Model: Brz-P1	Date: 23-May-16	No.: RM281002c
----------------------	-----------------	----------------

Subject: Firmware Problems/Original		Reasons for original problem have been corrected or addressed		Prepared by: T. Tachibana	
From: 2nd Tech Service Sect., MFP/Printer Tech Service Dept.					
Classification:	<input type="checkbox"/> Troubleshooting	<input type="checkbox"/> Part information	<input type="checkbox"/> Action required		
	<input type="checkbox"/> Mechanical	<input type="checkbox"/> Electrical	<input type="checkbox"/> Service manual revision		
	<input type="checkbox"/> Paper path	<input type="checkbox"/> Transmit/receive	<input type="checkbox"/> Retrofit information		
	<input type="checkbox"/> Product Safety	<input checked="" type="checkbox"/> Other (Firmware)	<input checked="" type="checkbox"/> Tier 2

Model: Brz-P1		Date: 31-Aug-16	No.: RM281017
Subject: Parts Catalog Correction on Operation Panel		Prepared by: T. Tachibana	
From: 2nd Tech Service Sect., MFP/P Tech Service Dept.			
Classification:	<input type="checkbox"/> Troubleshooting <input type="checkbox"/> Mechanical <input type="checkbox"/> Paper path <input type="checkbox"/> Product Safety	<input checked="" t

1.Covers

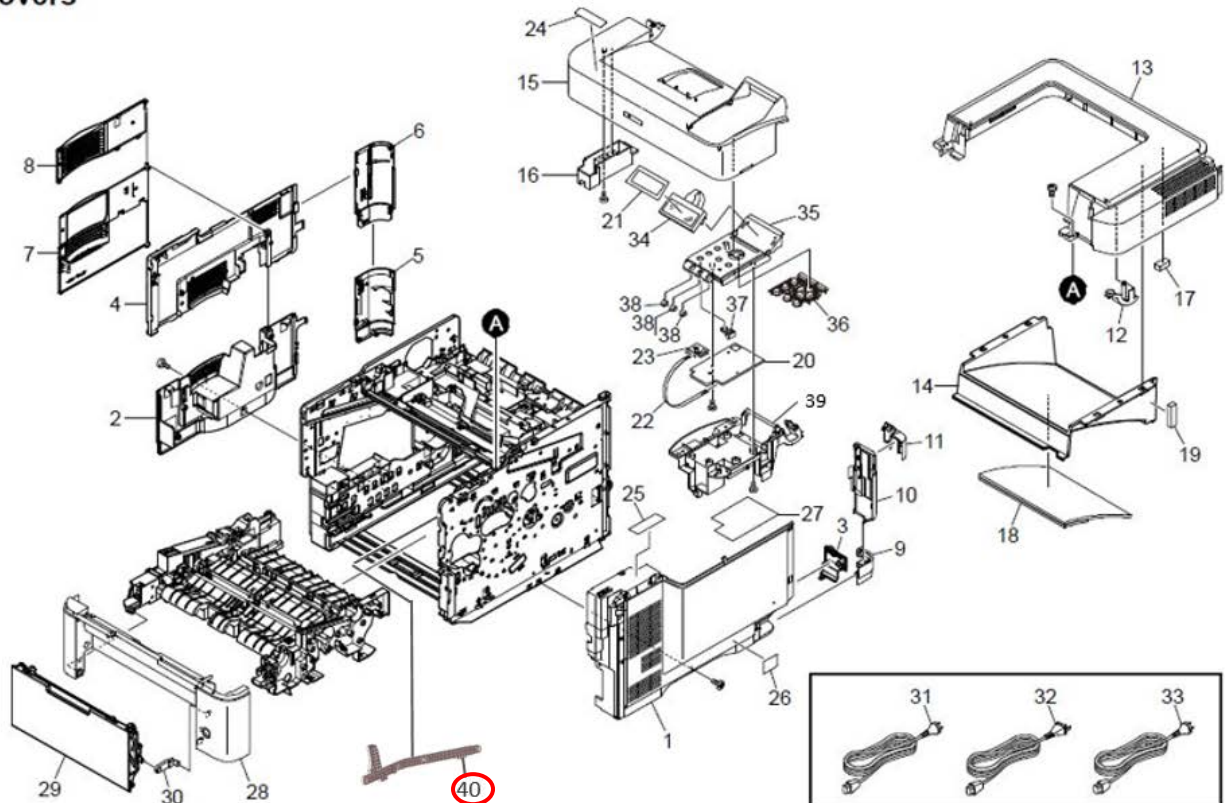
Change: This part is newly added.

Part number	Description	Q'ty	Int	Page	Index	Note
M2811139	ARM COUPLING	1		4	40

1.Covers

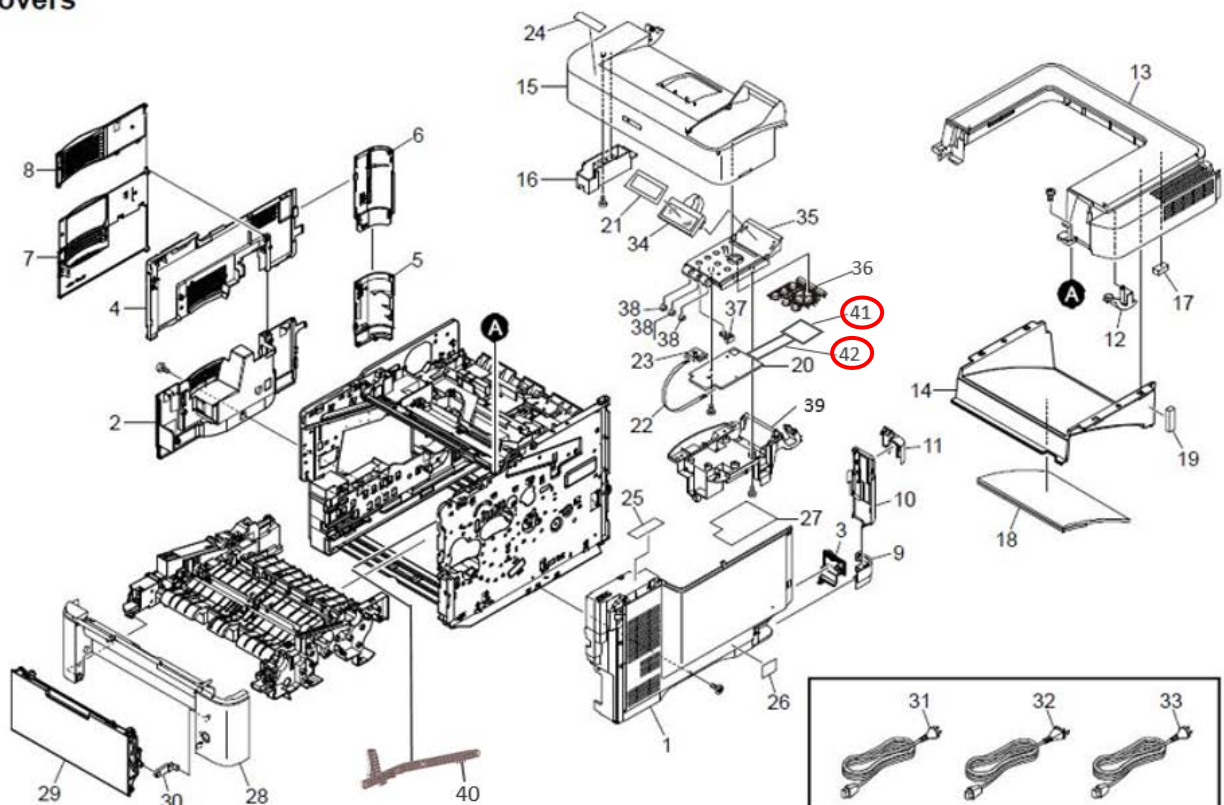
Change: This part is newly added.

Part number	Description	Q'ty	Int	Page	Index	Note
M2811430	PARTS PWB ASSY THERMISTOR SP (Temperature Sensor)	1		4	41	
M2815403	HARNESS: PANEL-THERM	1		4	42

4. Paper Feed Section

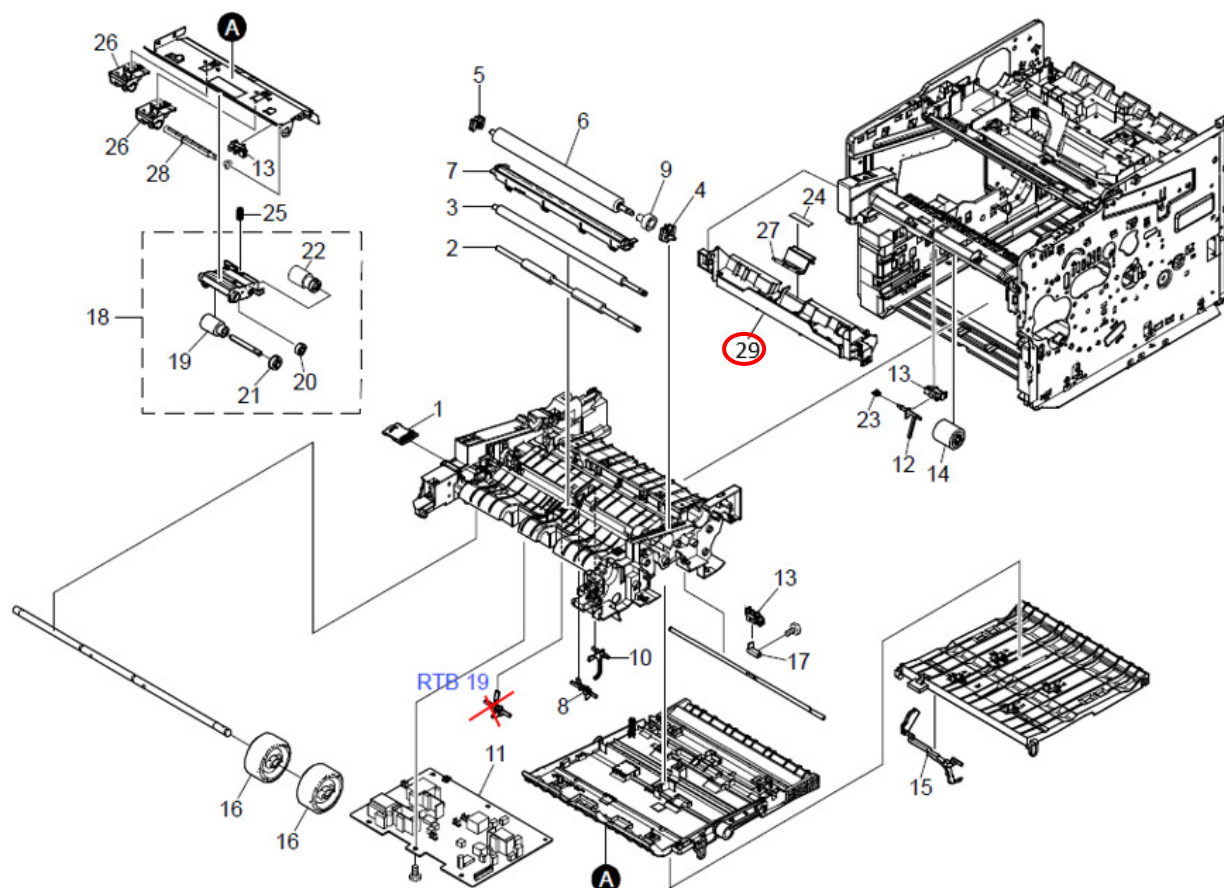
Change: This part is newly added.

Part number	Description	Q'ty	Int	Page	Index	Note
M2812851	GUIDE TURN MPF A	1		10	29

9. Drive Section

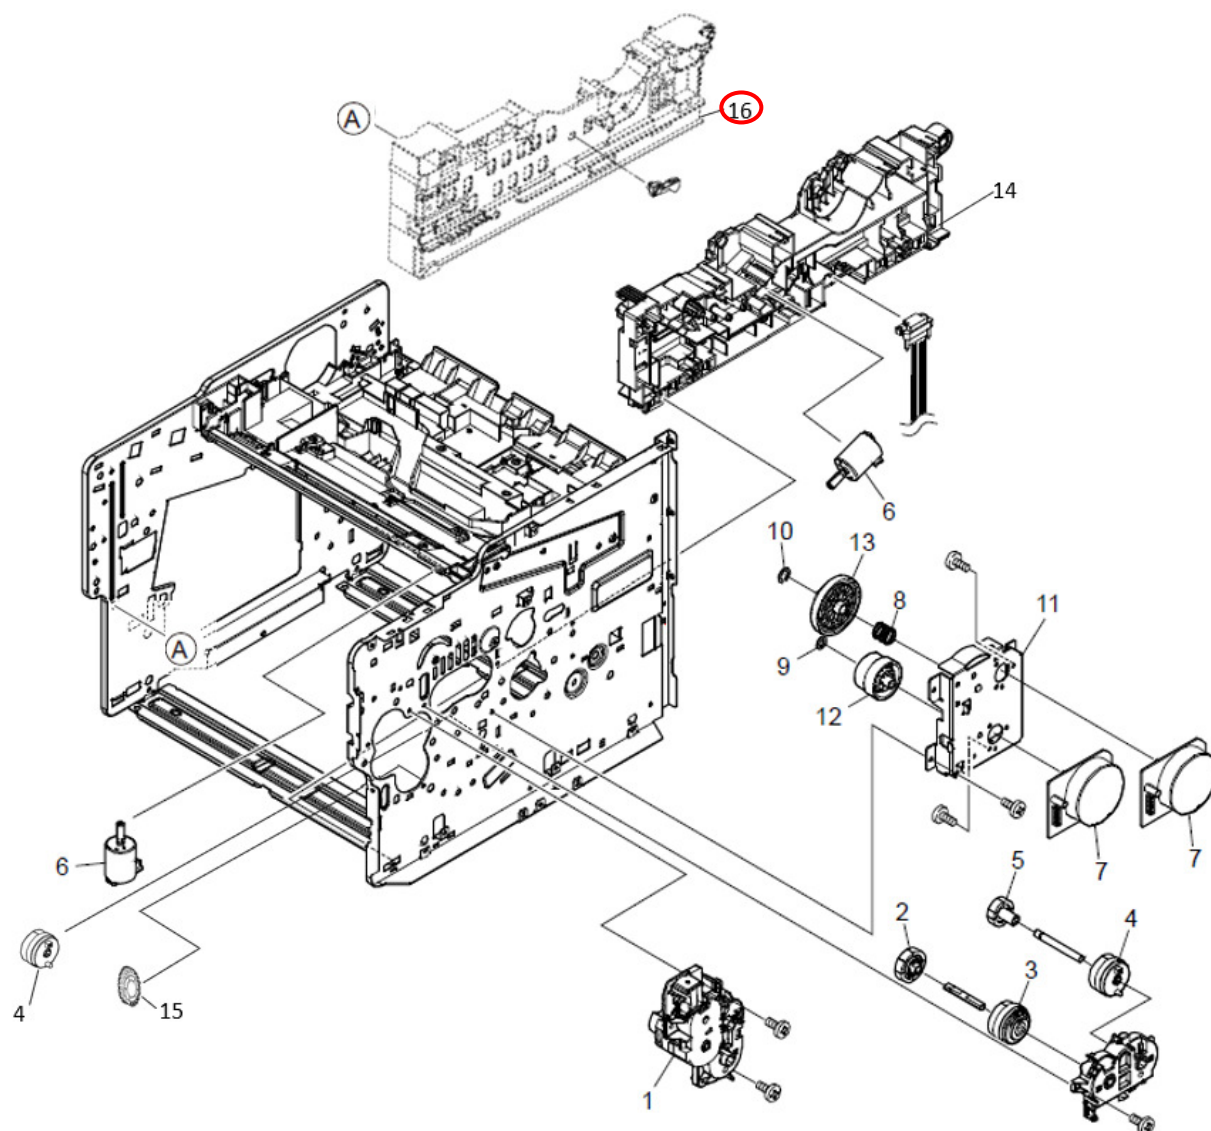
Change: This part is newly added.

Part number	Description	Q'ty	Int	Page	Index	Note
M2811183	GUIDE CASSETTE L	1		20	16

3. Paper Cassette

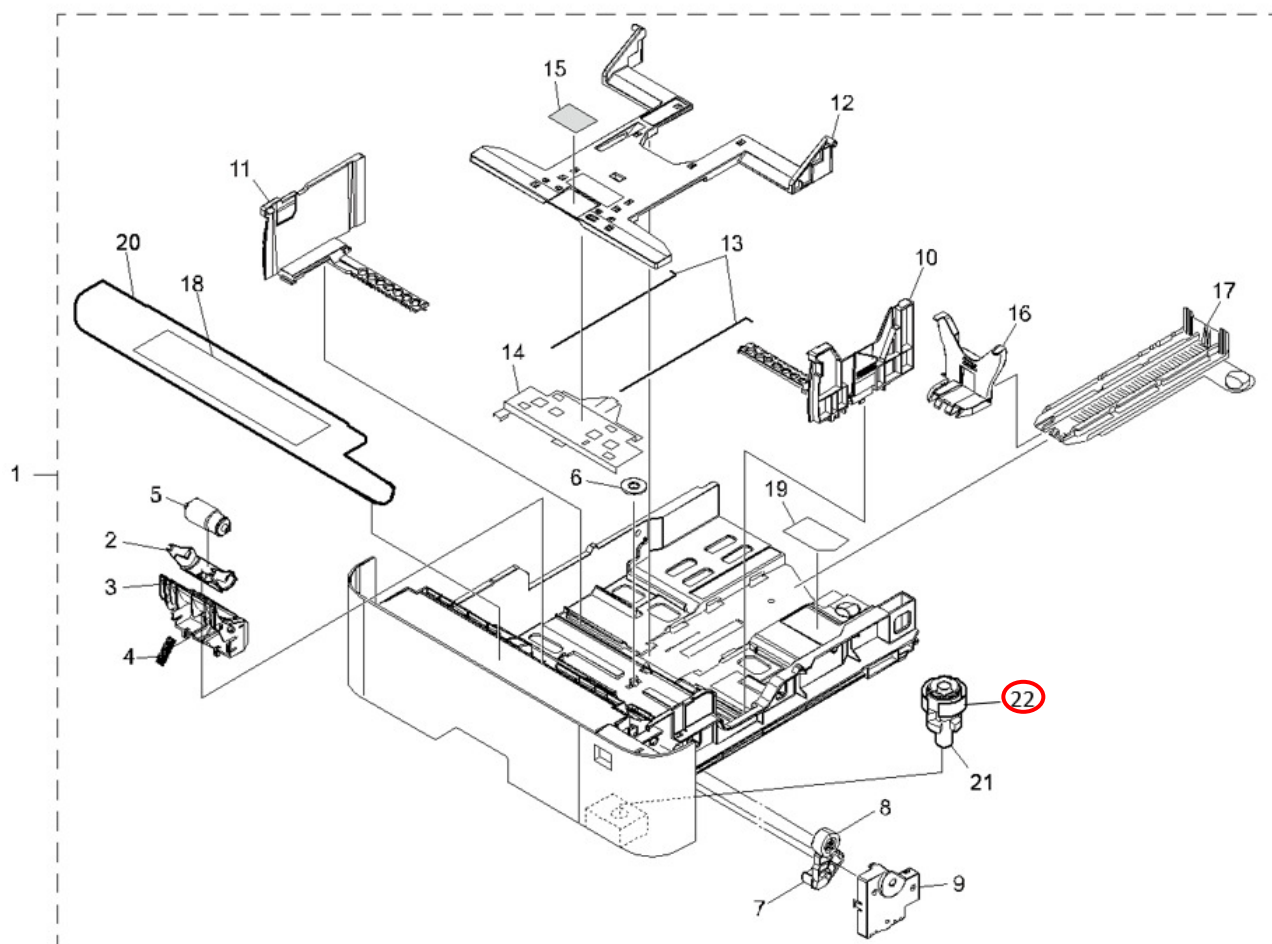
Change: This part is newly added.

Part number	Description	Q'ty	Int	Page	Index	Note
M2811316	LABEL_DIAL	1		8	22

9. Drive Section

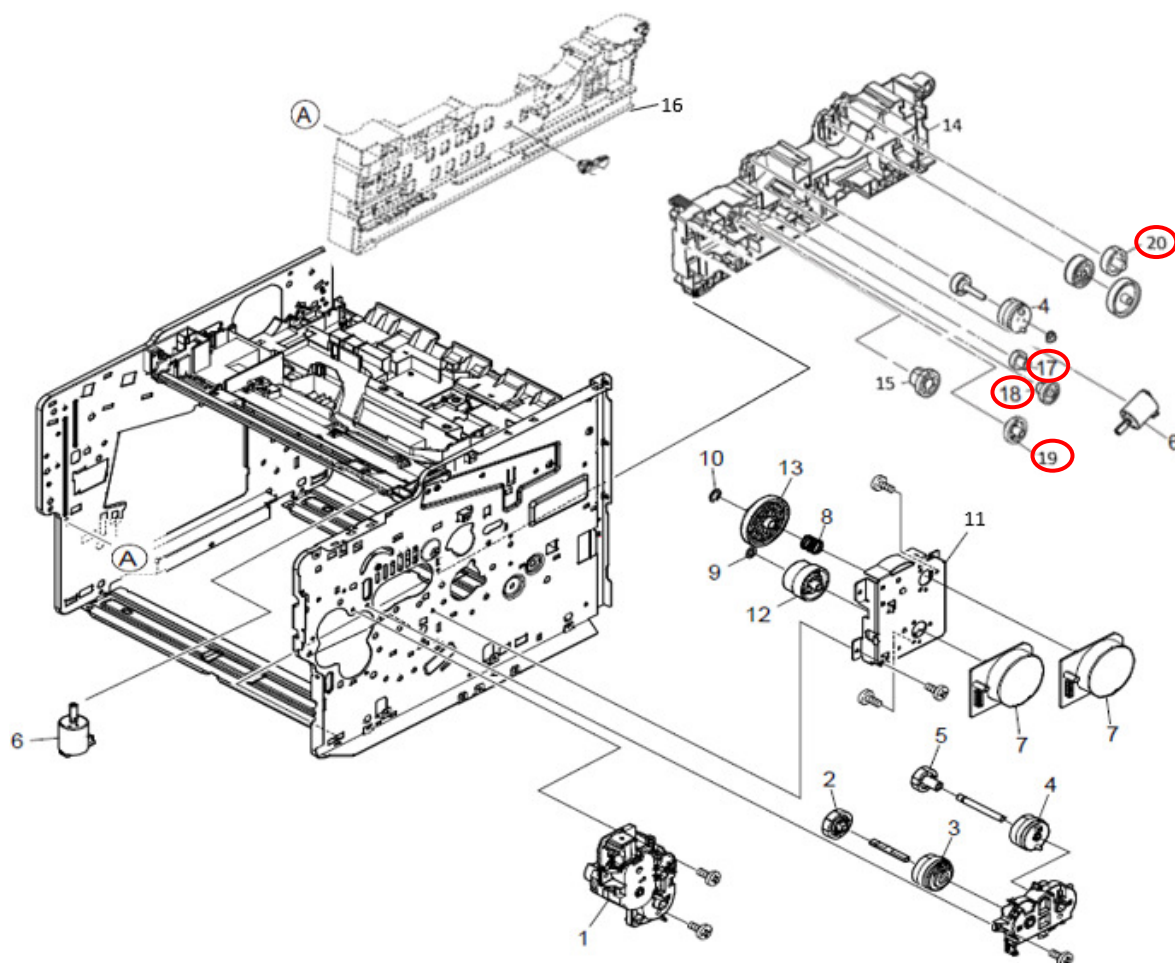
Change: These parts are newly added.

Part number	Description	Q'ty	Int	Page	Index	Note
M2812543	GEAR Z36L-Z20S	1		20	17	
M2812542	GEAR Z46S-Z13S	1		20	18	
M2812541	GEAR Z34S-Z13S	1		20	19	
M2817501	GEAR Z34S INPUT	1		20	20

4. Paper Feed Section

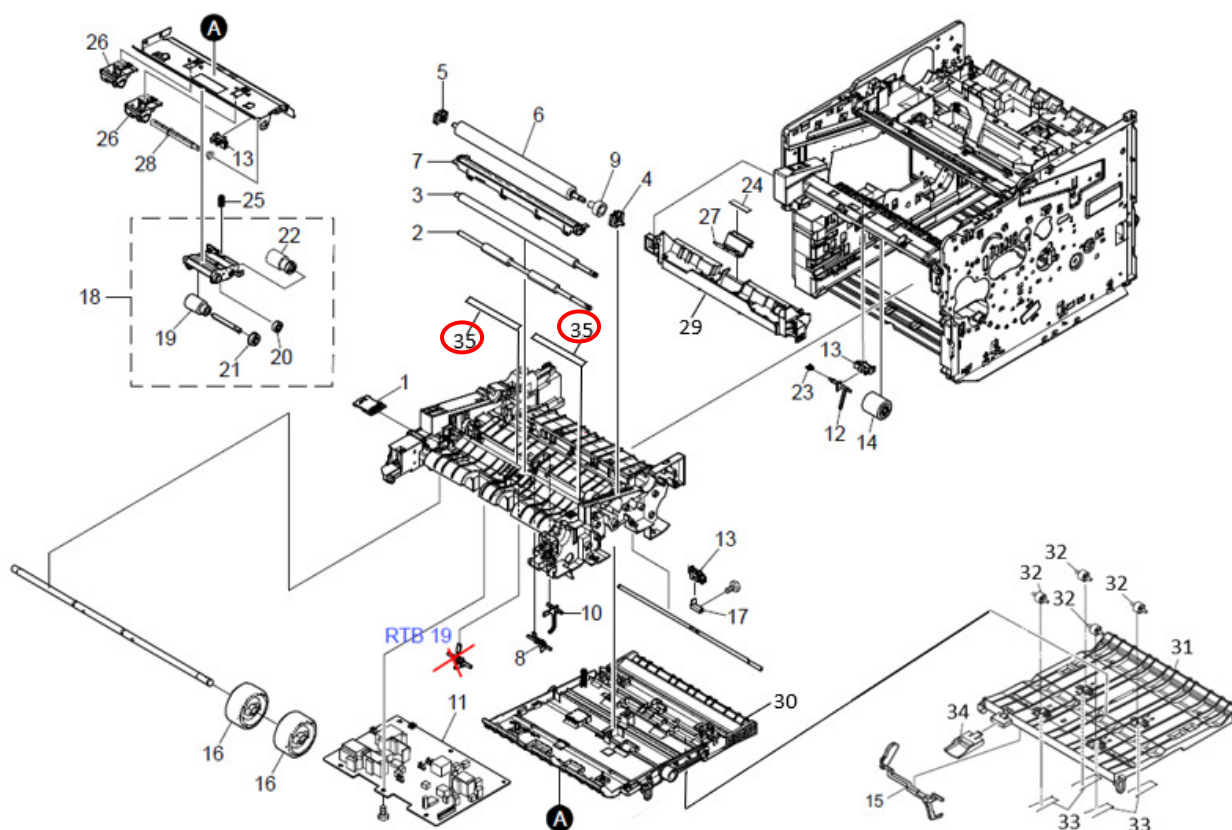
Change: This part is newly added.

Part number	Description	Q'ty	Int	Page	Index	Note
M2817505	SHEET REGIST	2		10	35

9. Drive Section

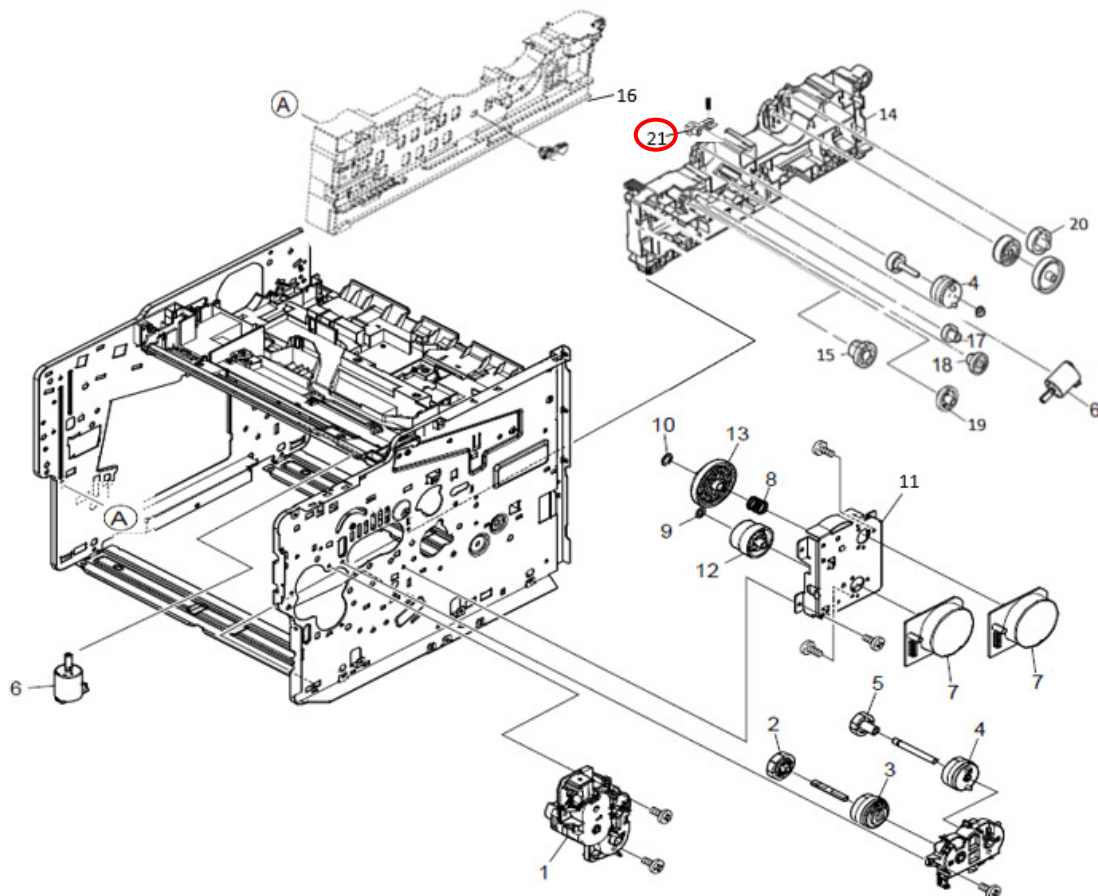
Change: This part is newly added.

Part number	Description	Q'ty	Int	Page	Index	Note
M2817506	LEVER LOCK CASSETTE L	1		20	21

4. Paper Feed Section

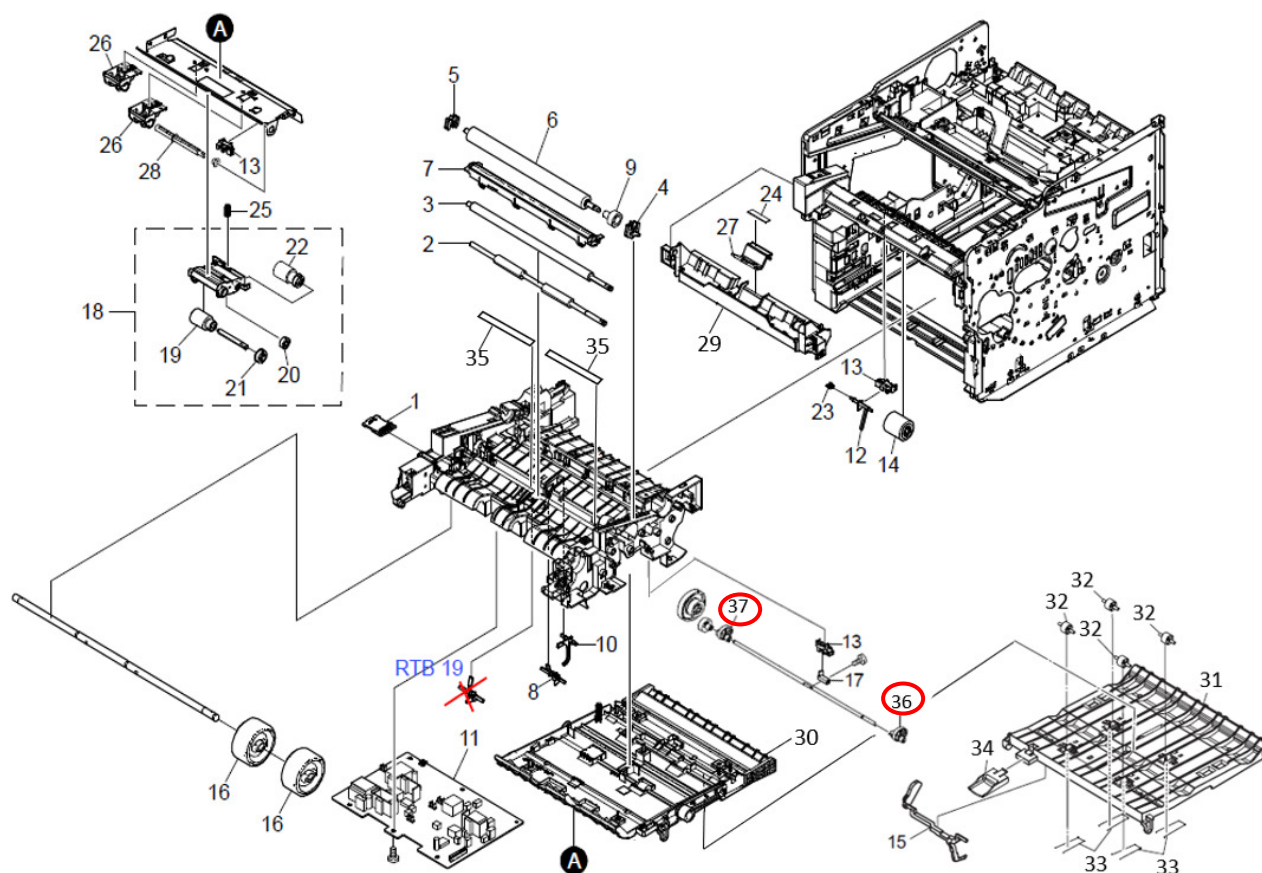
Change: *The bold italic parts* are newly added.

Part number	Description	Q'ty	Int	Page	Index	Note
D2552851	GUIDE TURN MPF A	1		10	29	
M2812852	BASE_DU	1		10	30	
M2817502	GUIDE DU	1		10	31	
M2817503	PULLEY PA	4		10	32	
M2817504	SPRING DU	4		10	33	
M2816684	LEVER_DU_RELEASE	1		10	34	
M2817505	SHEET REGIST	2		10	35	
M2812859	LOCK ENVELOPE R	1		10	36	
M2812855	LOCK ENVELOPE L	1		10	37
